MONTGOMERY COUNTY PLANNING DEPARTMENT

SUBJECT: Urban Design Response to Public Testimony Districts located west
of I-270, Germantown

Germantown Historic District Draft Clare Lise Kelly 9-22-08

Urban Design and Preservation of Germantown Historic District

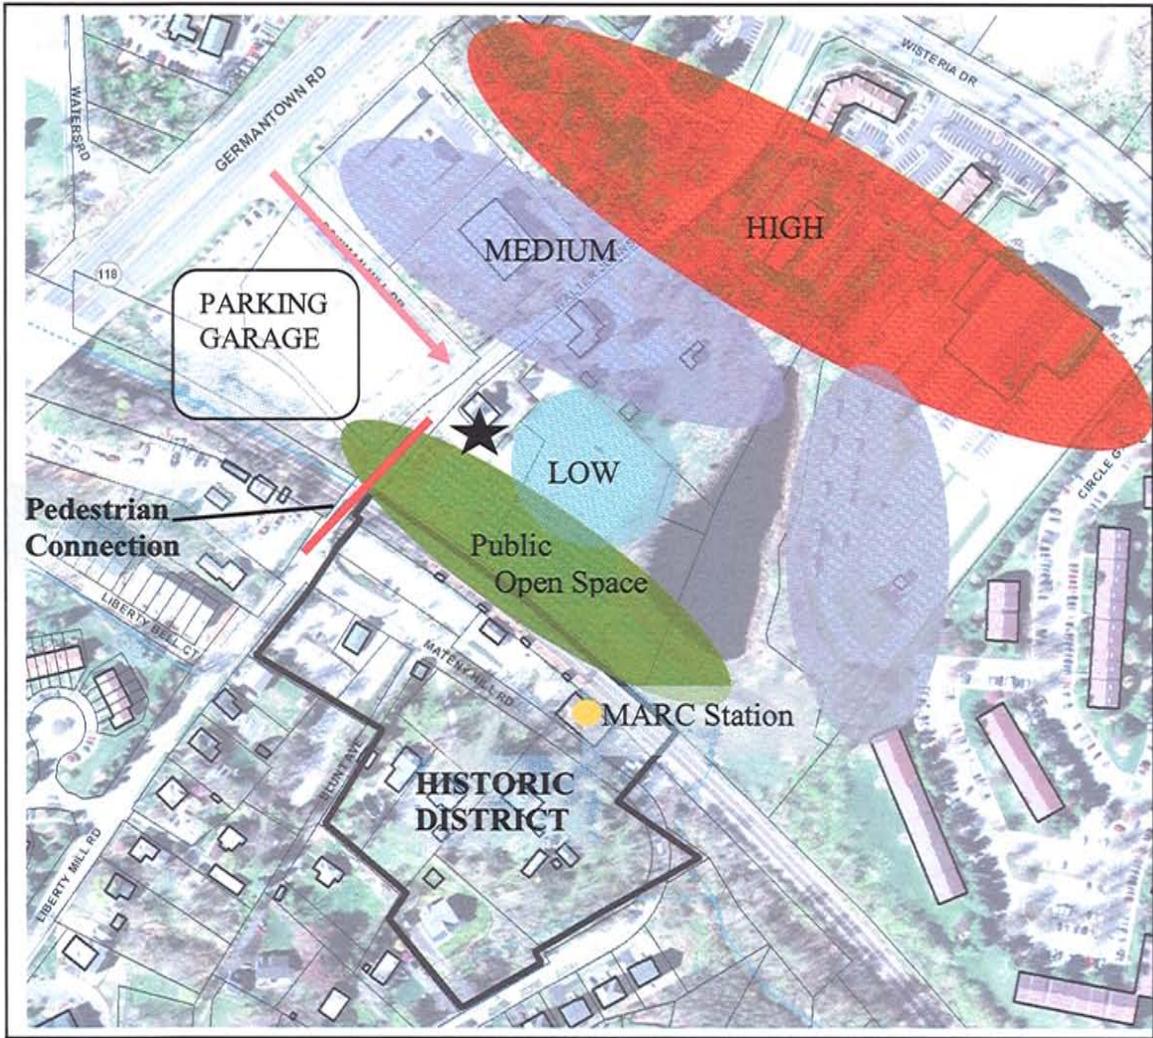
ID	Person	Comments	Response
10	Susan Soderberg Germantown Historical Society	Destroying the historicity of the place	Staff recommends preserving the context of the historic district and the Pumphrey-Matney House by enlarging public open space on the north edge of the district and establishing graduated heights extending north. MARC parking to be moved to a parking garage along Rt 118.
46	Diane Schwartz Jones County Executive	Expand MRC parking spaces as part of West End land use recommendations	If surface lot is eliminated and parking garage built, there be a net gain of parking.
38	Phil Perrine	TMX zone limits to 28'. Wants 50' for DLSS Property on Walter Johnson Drive	Graduated height limits from public space along tracks moving northward.

New construction and development within walking distance of transit stops afford opportunities for design in accordance with growth management goals. (Attachment 2) The MARC train runs along the old Metropolitan Branch of the B&O Railroad established in 1873. The Germantown Historic District grew along that railroad line. This area requires a delicate balance, offering opportunities for growth to accomplish goals of neighborhoods and businesses in walking distance of transit stops, yet requiring preservation of a significant historic community. The MARC station area is an opportunity to be a vital center balancing historic and new elements. Design public space and streets to effectively connect new development into the transition area and the historic district.

The topography at the MARC station is challenging. The land on the north side of the tracks currently occupied by a parking lot is at a higher elevation than the historic district, located south of the tracks. This elevated area north of the tracks and immediately adjacent is culturally sensitive. Construction of buildings along this area would negatively impact the historic district. A small park already exists on the north side of the tracks, and linear greenspace exists along the railroad tracks extending east and west. Expansion of this park would provide a buffer between the historic district and development north of the tracks, preserve the vista to and from the historic district, and enhance a public amenity that would offer an opportunity for interpretation of Germantown's railroad history. A pedestrian bridge (Walter Johnson Road to Liberty Mill Road) connects these two areas. Appropriate height and setback requirements to control massing and scale of the low-scale development adjacent to the greenspace will guide context-sensitive development north of the tracks and enhance the visual connections and transition between the historic district and new development.

The Pumphrey-Mateny House is located north of the public space area. A commercially compatible use for the historic building could be appropriate given its location in an area targeted for TMX zone. The area from the railroad tracks north to Wisteria Drive and west to Germantown Road is identified with graduated height and density, with the lowest height being near the public open space and the Pumphrey-Mateny House. Development in the area near the Pumphrey-Mateny House will be no taller than the ridgeline of the historic house.
